1992 Corvette: Service Bulletin: Harsh 1-2 Upshift

Subject: HARSH 1-2 UPSHIFT INSTALL SERVICE PACKAGE
Model and Year: 1992 CAPRICE, CAMARO AND CORVETTE 1992 C/K, G, L/M, S/T TRUCKS
Source: Chevrolet Service Bulletin
Bulletin Number: 92-318-7A - (09/15/1992)

TRANSMISSION APPLICATIONS: SUBJECT: 1992 HYDRA-MATIC 4L60 Harsh 1-2 Upshift ;Install Service Package

Figure 1 - HYDRA-MATIC 4L60 Transmission Identification Information

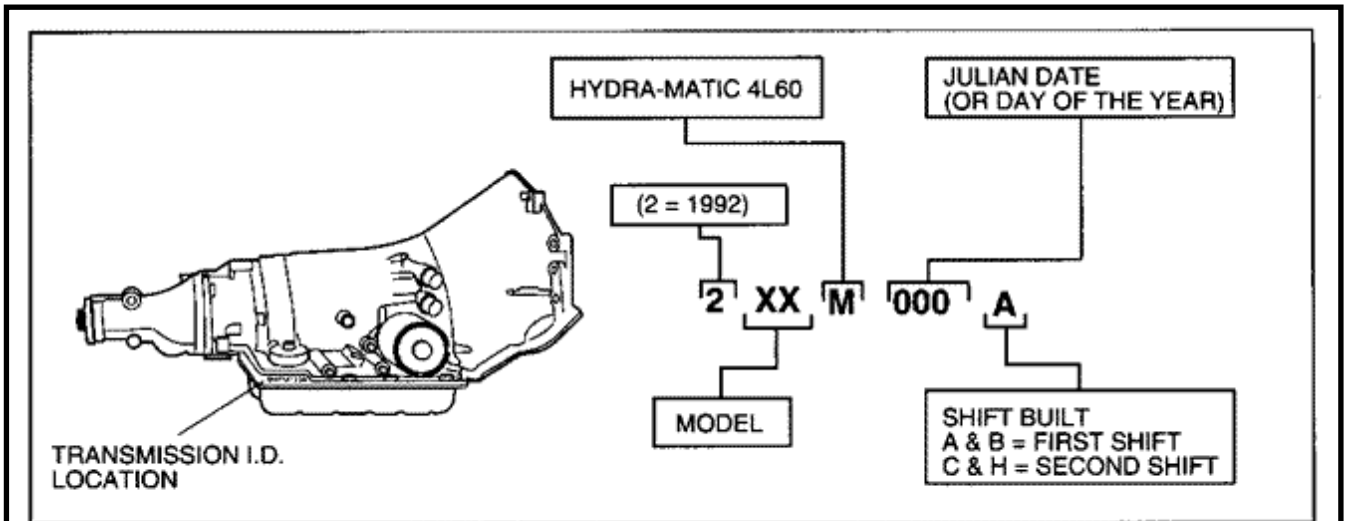
CONDITION (Figure 1):

Some vehicles equipped with a 1992 HYDRA-MATIC 4L60 transmission built between Julian Date 061 (March 1, 1992) and Julian Date 171 (June 19, 1992) may experience a harsh 1-2 upshift. NOTE: Once the transmission is brought to operating temperature, the condition may not be able to be reproduced until a "cold soak" (overnight) is performed.

Figure 2

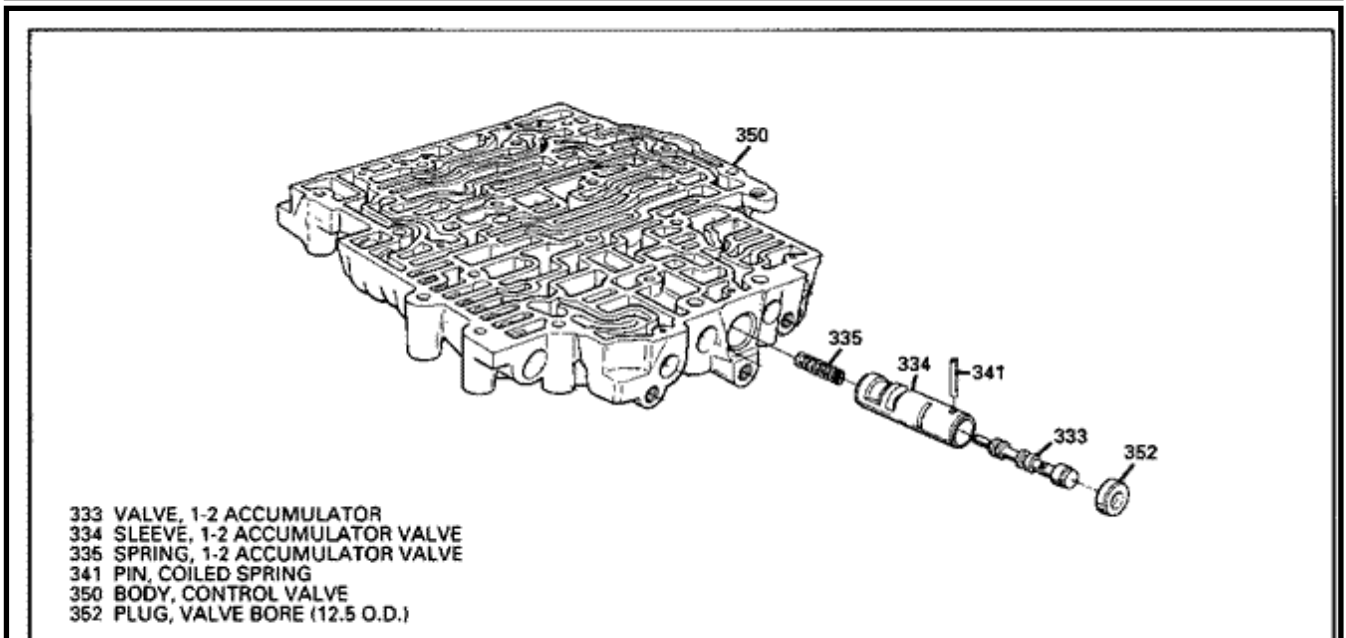
The above condition may be caused due to a tapered 1-2 accumulator sleeve. The tapered bore may cause the 1-2 accumulator valve to stick in the bottom of the bore.

CORRECTION (Figure 2):

To improve the 1-2 shift, install the service package listed in this bulletin. A 1-2 accumulator valve and 1-2 accumulator valve sleeve (which, normally, is not serviceable) is included in the package.
